Addendum Number: 03

Owner: Robinson-Palestine Water Commission

Project Name: Water Treatment Plant and Campus

Project Number: 0210007.00

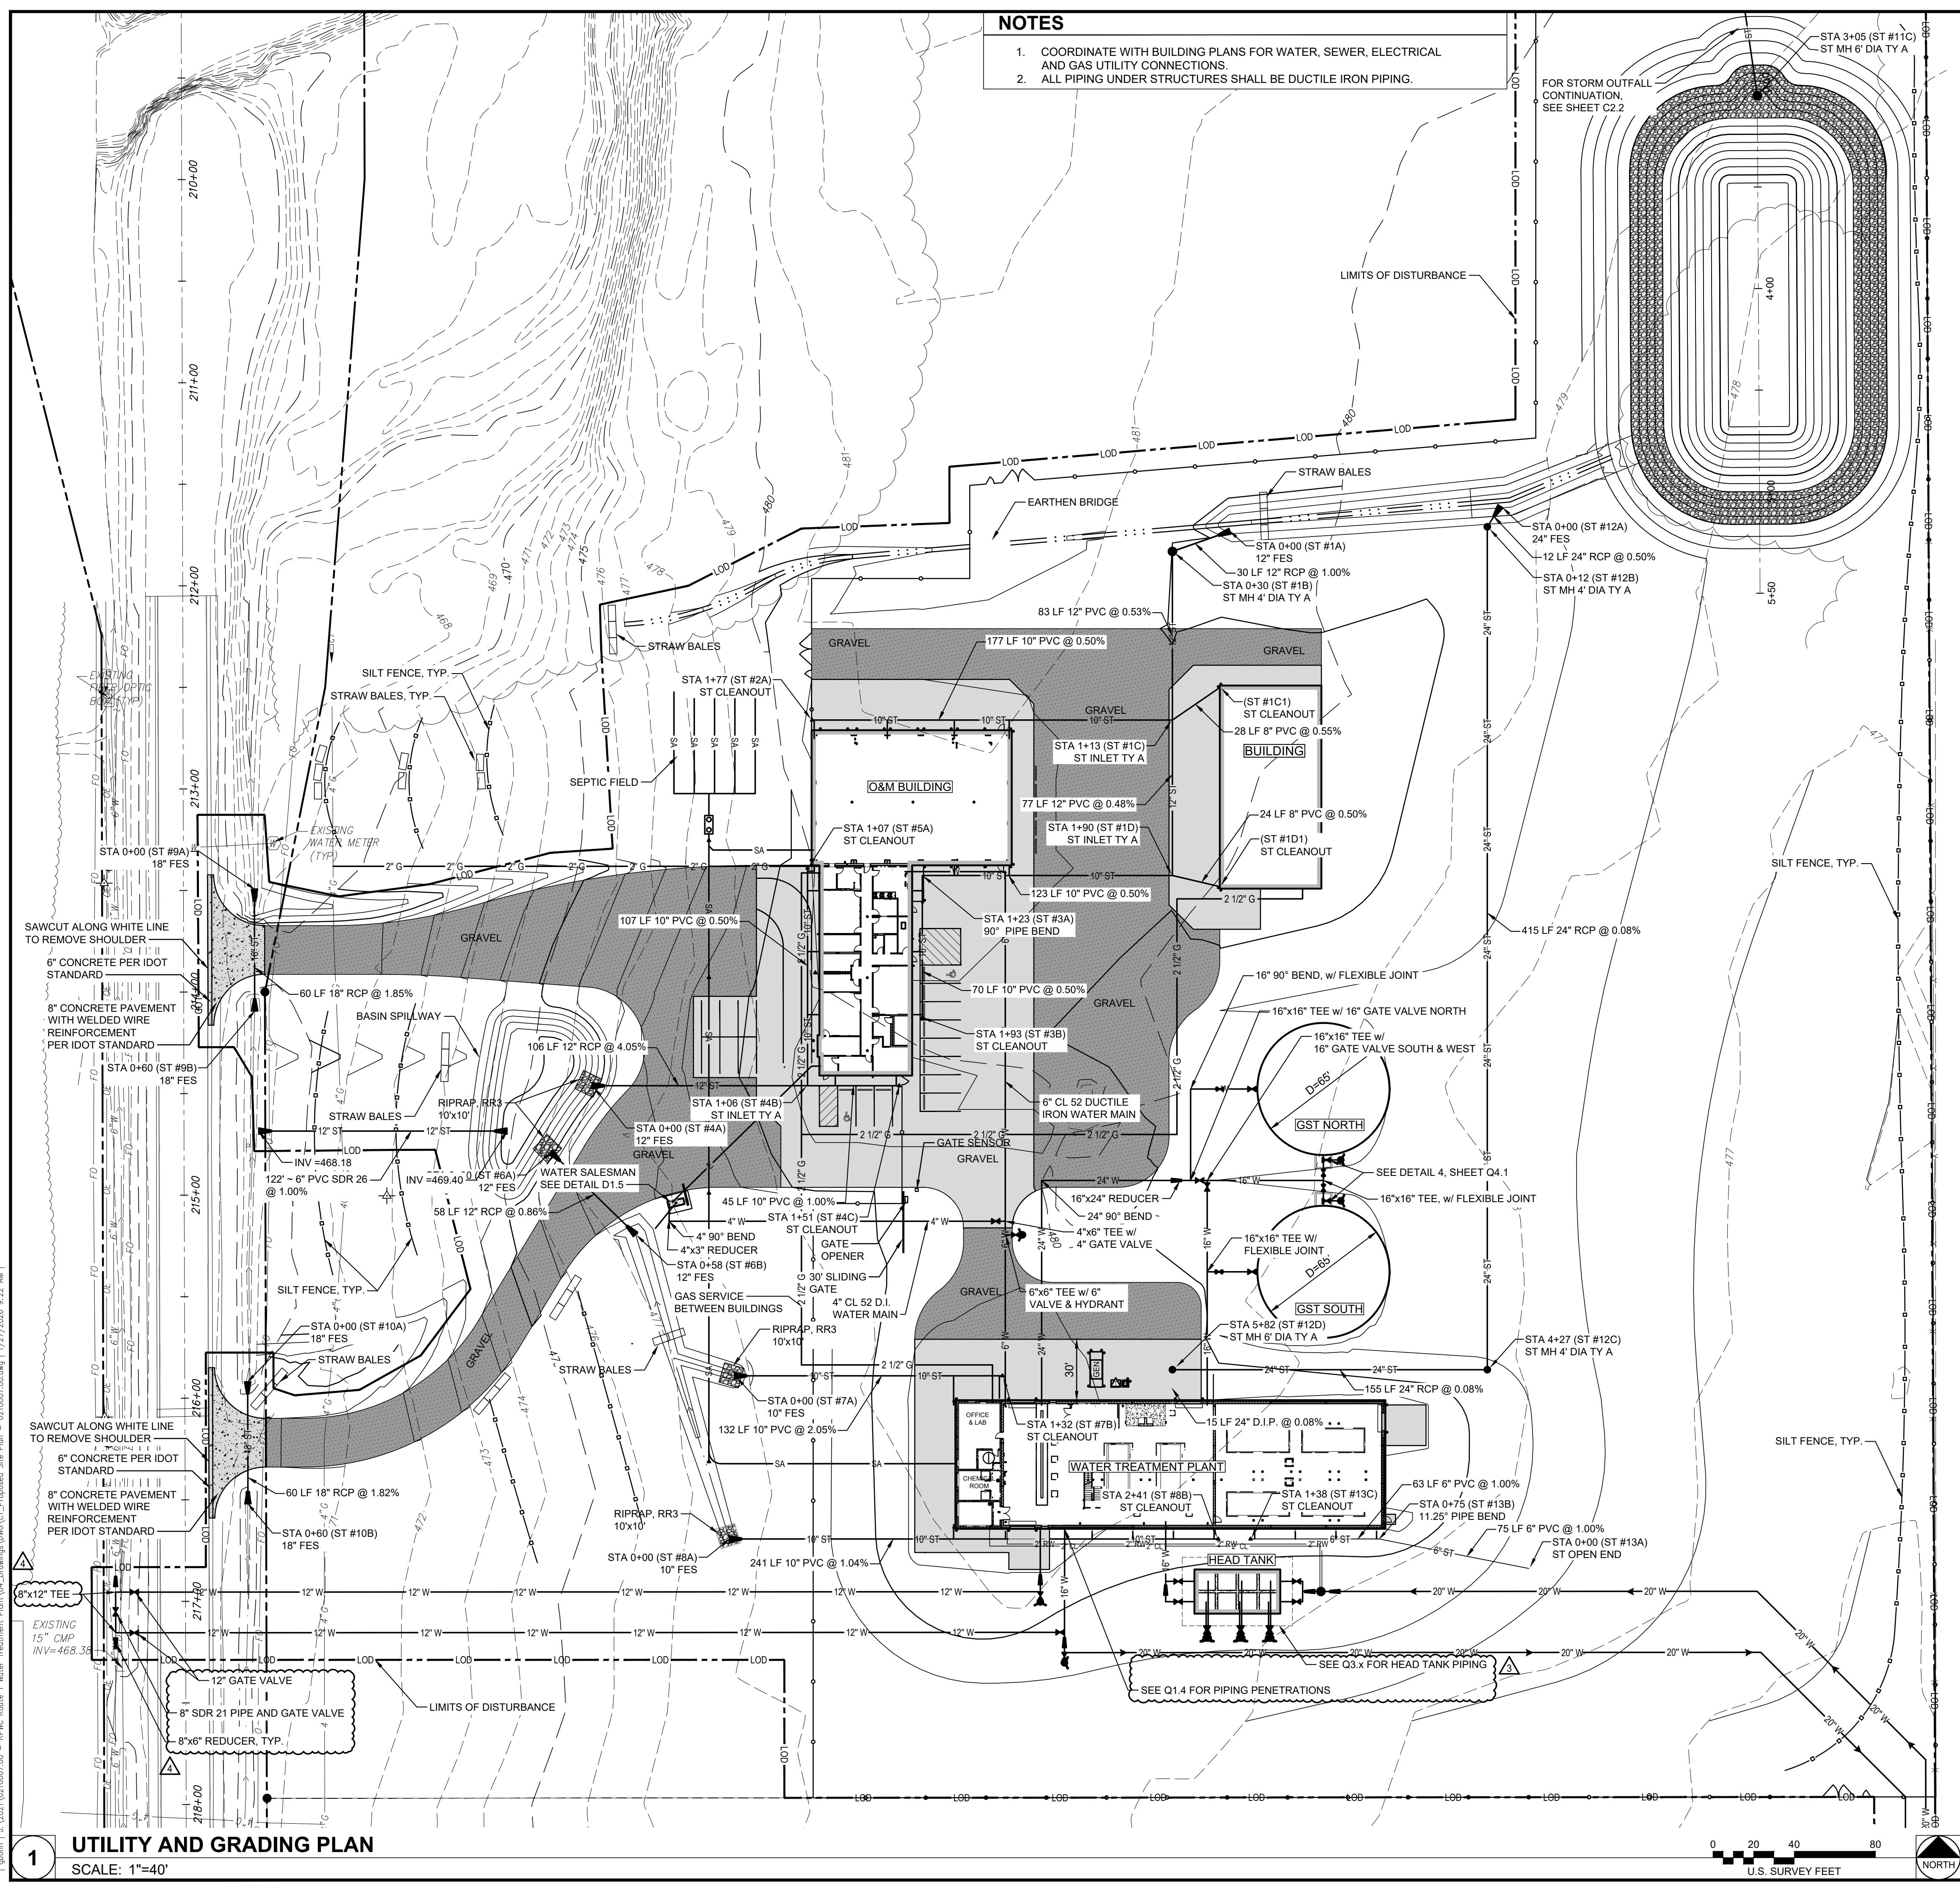
- 1P1.1 – FIRST FLOOR PLUMBING PLAN – O/M
 - REVISE Kitchen sink designation to "SK-3."
- GP6.1 – SCHEDULES
 - ADD description for SK-3 to plumbing fixture schedule.

SK-3	SINK: DROP-IN, TWO-COMPARTMENT, 18 GAUGE 304 STAINLESS STEEL, 29 INCH x 18 INCH x 7 5/8 INCH DEEP, UNDERCOATED, THREE HOLE, 3 1/2 INCH DRIN. ACCEPTABLE MANUFACTURERS: ELKAY LR3319 OR APPROVED EQUIVALENT BY JUST, FRANKE, KOHLER. FAUCET: 8 INCH RIGID/SWING GOOSENECK, 8 INCH FIXED CENTERS, 4 INCH WRIST BLADE HANDLES, 2.2 GPM AERATOR, CERAMIC CARTRIDGES ACCEPTABLE MANUFACTURERS: CHICAGO FAUCETS MODEL 786-E3XKABCP OR APPROVED EQUIVALENT BY ZURN, T&S BRASS. TRIM: BASKET STRAINER, 17 GAUGE 1 1/2 INCH TAILPIECE AND 17 GAUGE 1 1/2 INCH P-TRAP BY BRASSCRAFT, MCGUIRE, OR DEARBORN, ANGLE STOPS BY BRASSCRAFT OR MCGUIRE, BRAIDED STEEL SUPPLIES. NOTES/ACCESSORIES: VERIFY EQUIPMENT LOCATION AND ROUGH IN REQUIREMENTS.	1/2" 1/2" 1 1/2" 1 1/2"
UR-1	URINAL: WALL MOUNTED, WHITE VITREOUS CHINA, SIPHON JET WITH INTEGRAL FLUSHING RIM AND TRAP, 3/4 INCH TOP SPUD. ACCEPTABLE MANUFACTURERS: AMERICAN STANDARD MODEL 6890.001 OR APPROVED EQUIVALENT BY KOHLER, GERBER. FLUSH VALVE: EXPOSED, TOP SPUD, 1.0 GPF, DIAPHRAGM, INTEGRAL SCREWDRIVER STOP, VACUUM BREAKER, POLISHED CHROME. ACCEPTABLE MANUFACTURERS: SLOAN MODEL ROYAL 180-1.0 OR

SHEET TITLE:
**OFFICE BUILDING
LIGHTING PLAN**

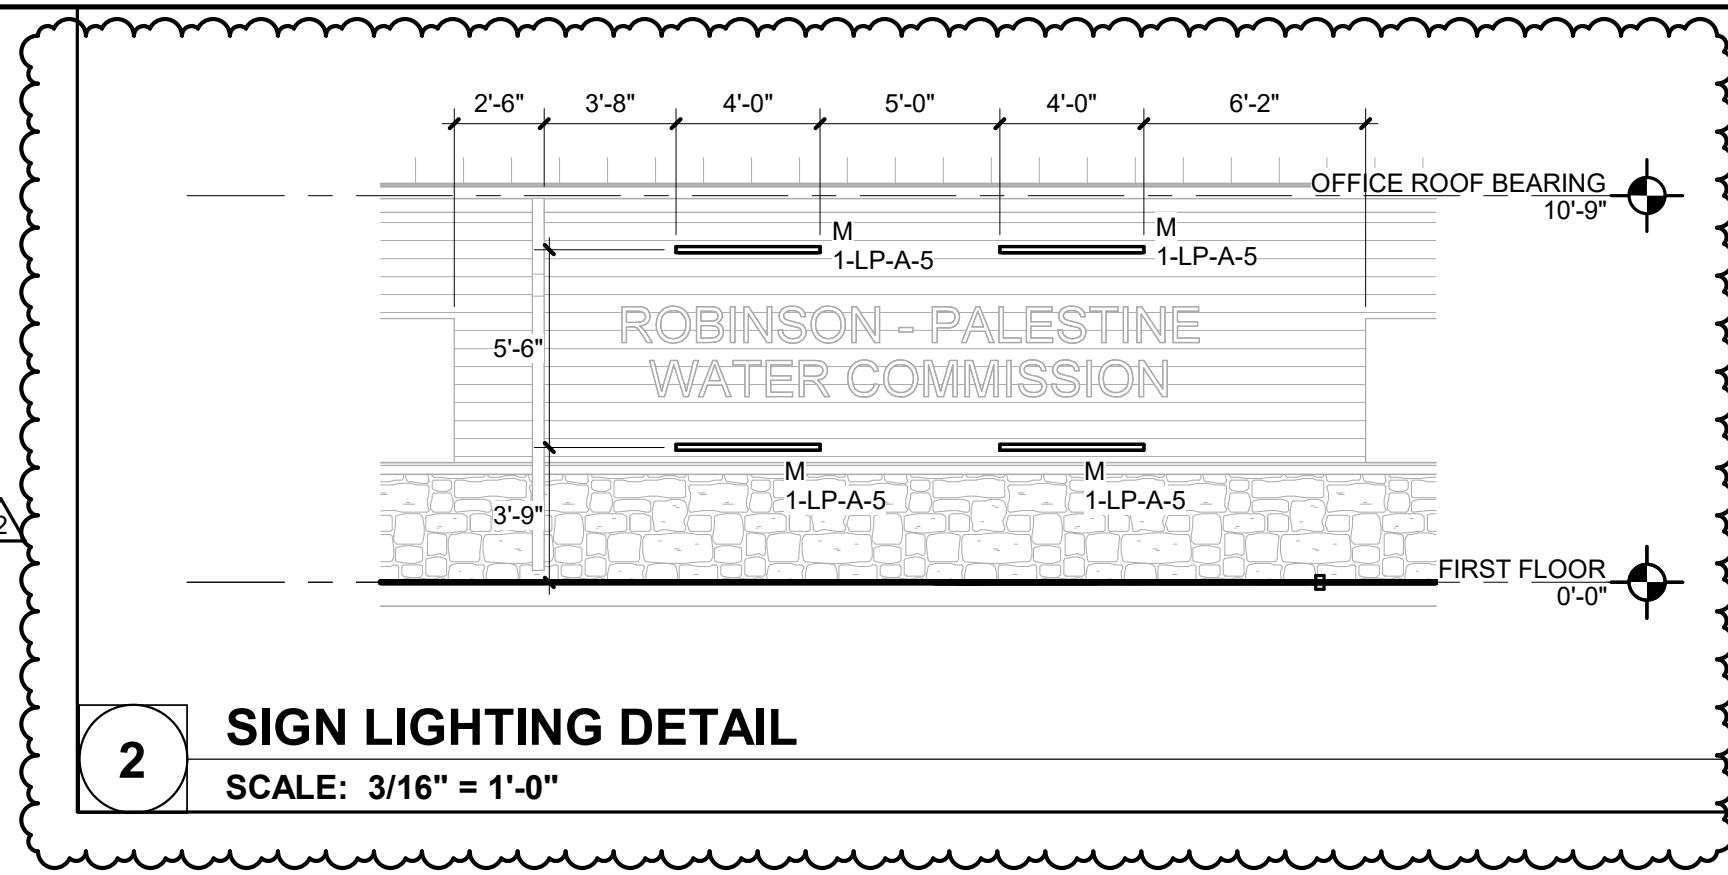
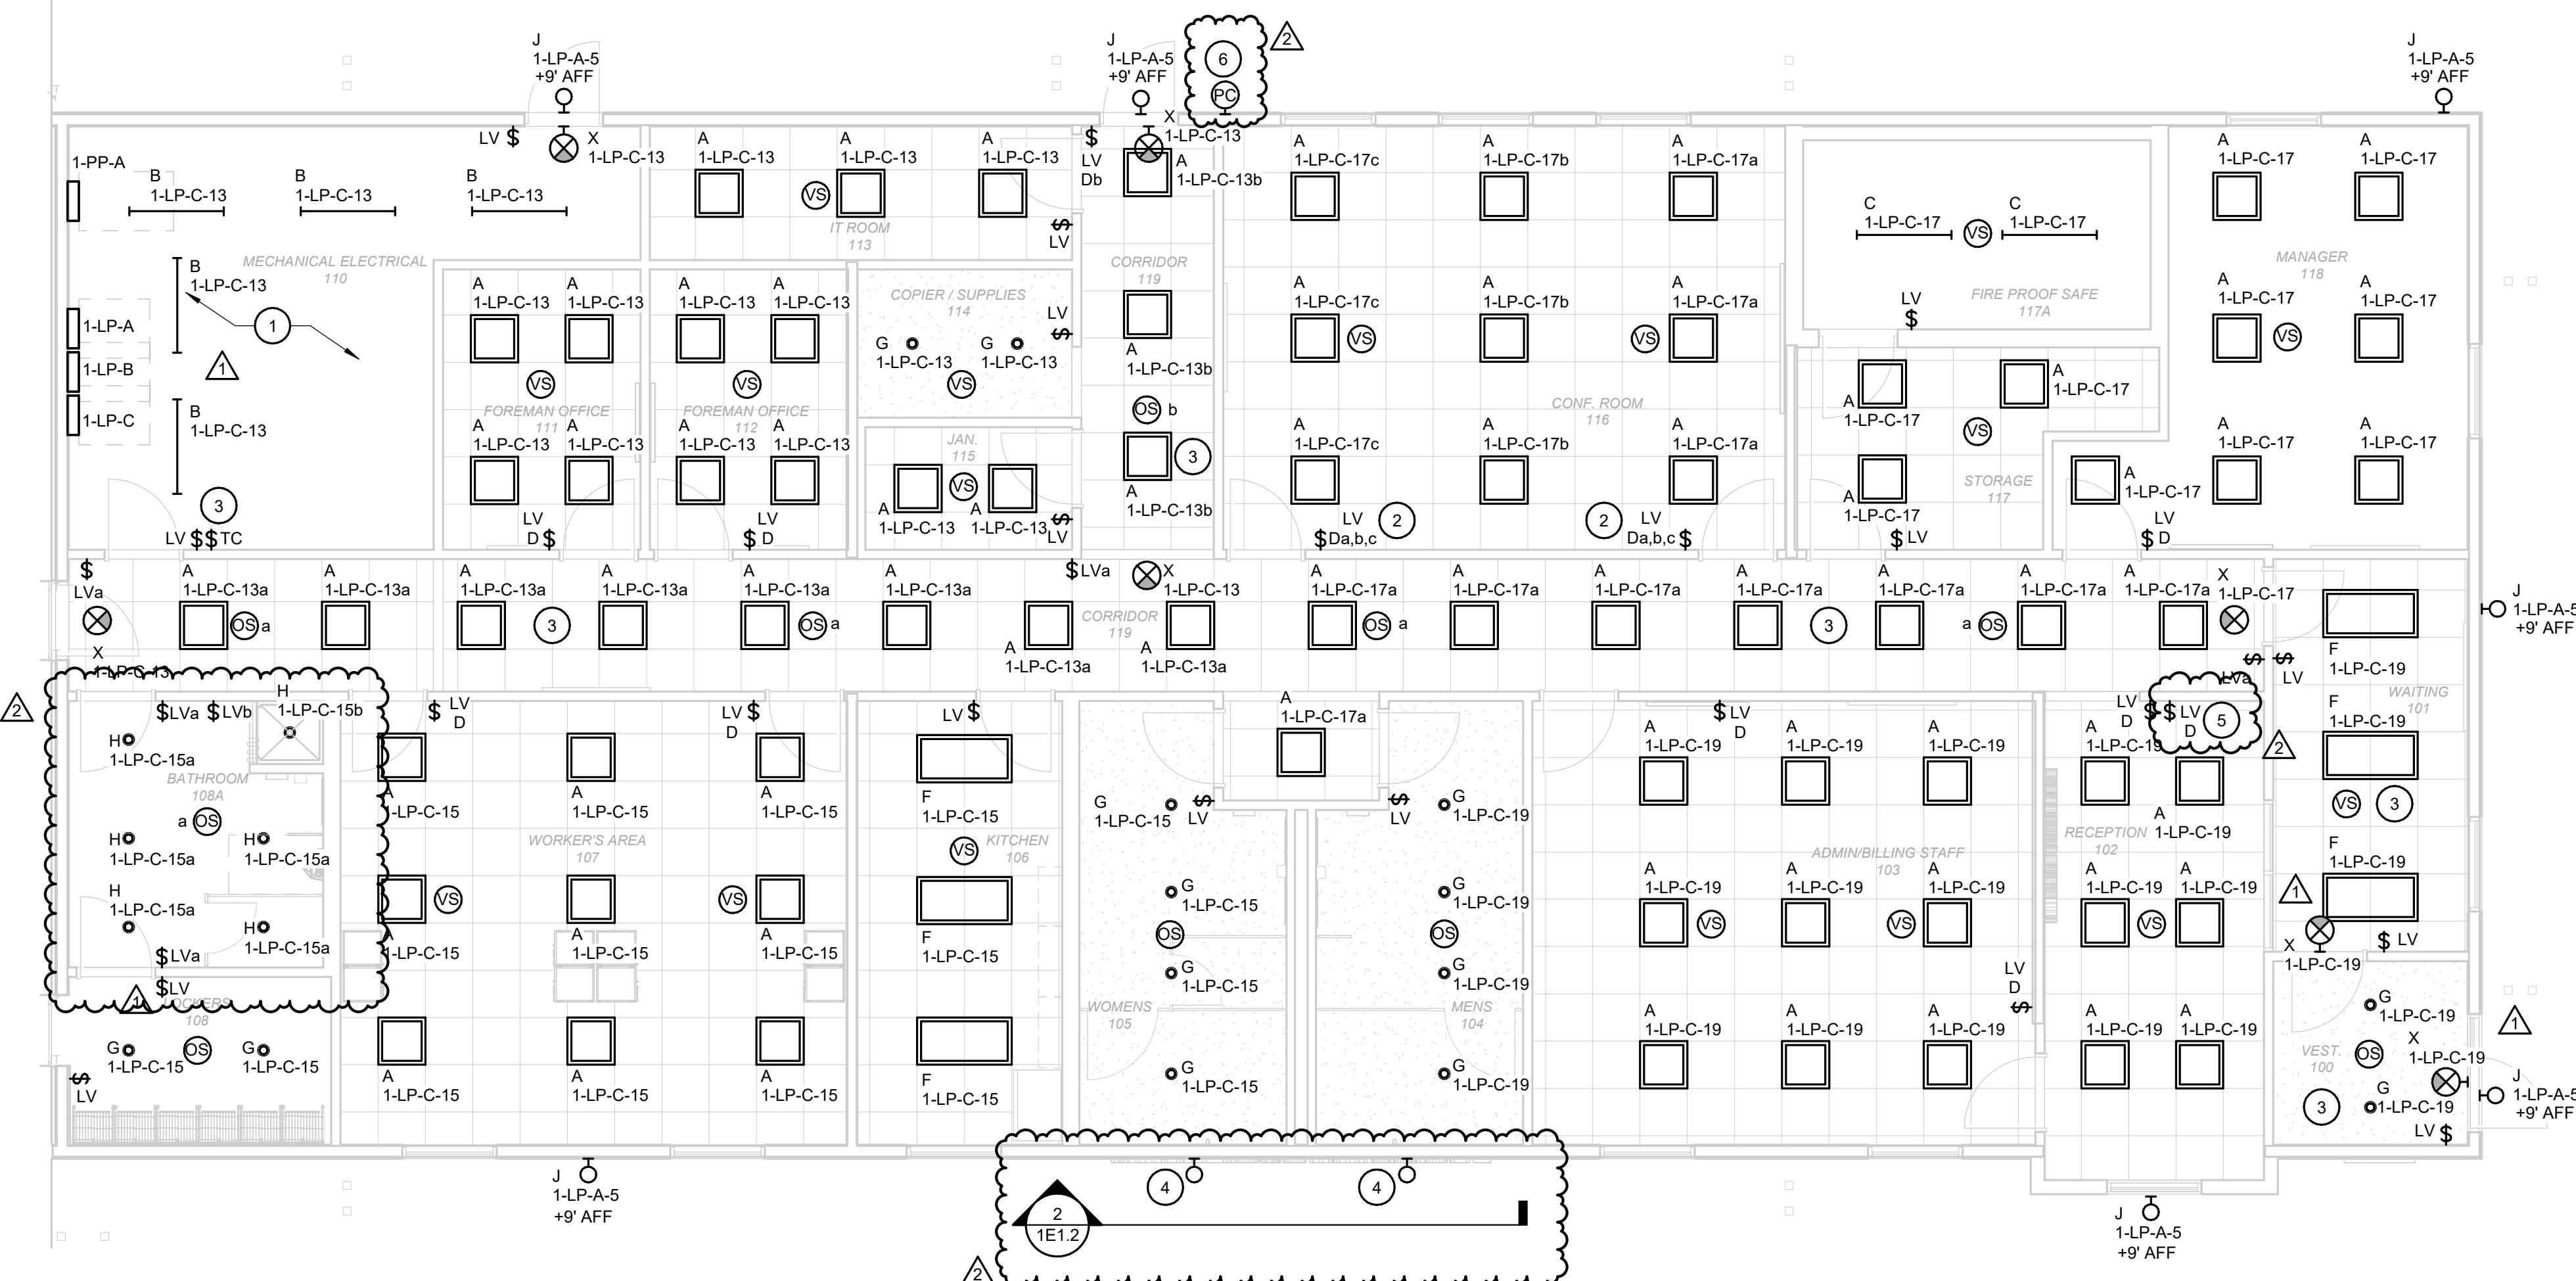
- 01A1.1 – FLOOR PLAN – O/M
 - REVISE Plan General Note K to be, "CONTRACTOR TO PROCURE ALL FURNITURE. SEE GI5.0 FOR FURNITURE INFORMATION."
- 02A1.1 – FLOOR PLAN – WTP
 - ADD Elevation marker for detail #7 in OFFICE AND LAB 201
- 02A8.1 – INTERIOR ELEVATIONS, ENLARGED PLANS, AND WINDOW DETAILS
 - ADD detail #7, OFFICE/LAB ELEVATION – PLAN WEST, as shown.
- GI5.0 – FURNITURE SCHEDULES
 - ADD Overall Size column to Furniture Schedule, as shown.
- GE5.1 – ELECTRICAL SITE SCHEDULES
 - ADD luminaire type M to luminaire schedule. See attached sheets.
- 1E1.2 – OFFICE BUILDING LIGHTING PLAN
 - ADD keynotes #4, 5, and 6. See attached sheets.

- ADD detail #2. See attached sheets.
- ADD luminaire type M. See attached sheets.
- ADD photocell and dimming switch. See attached sheets.
- ADD light switch for shower and switch legs. See attached sheets.

4. SEE DETAIL ON THIS SHEET FOR CIRCUIT, TYPE, MOUNTING HEIGHT, AND ADDITIONAL INFORMATION. VERIFY BRIGHTNESS LEVEL SET POINT WITH OWNER DURING COMMISSIONING.

5. DIMMING/ON/OFF OVERRIDE CONTROL FOR SIGN LIGHTING.
6. PROVIDE PHOTOCELL MOUNTED ON BUILDING EXTERIOR. PHOTOCELL TO PROVIDE ON/OFF CONTROL FOR SIGN LIGHTING.
